MODIFICATION SHEET NO. RDSO/2024/EL/MS/0499(Rev.0)

Provision of two LED indication lamps, LSIP1 in Cab-1 and LSIP2 in Cab-2, in conventional electric locomotives equipped with MPCS Version-3, to indicate the IP coil status (energized/de-energized) in case of DDU failure.

5.0 **MODIFICATION DRAWING:**

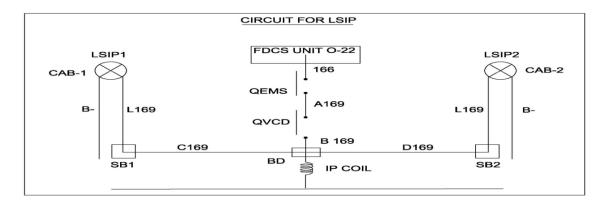
It is required to provide one LED indication lamp as LSIP1 in Cab-1 and another LED indication lamp as LSIP2 in Cab-2. The supply should be given from BD to LSIP1 and LSIP2 from cable 169, and other connections should be made as per the diagram provided in paragraph 5.0 below.
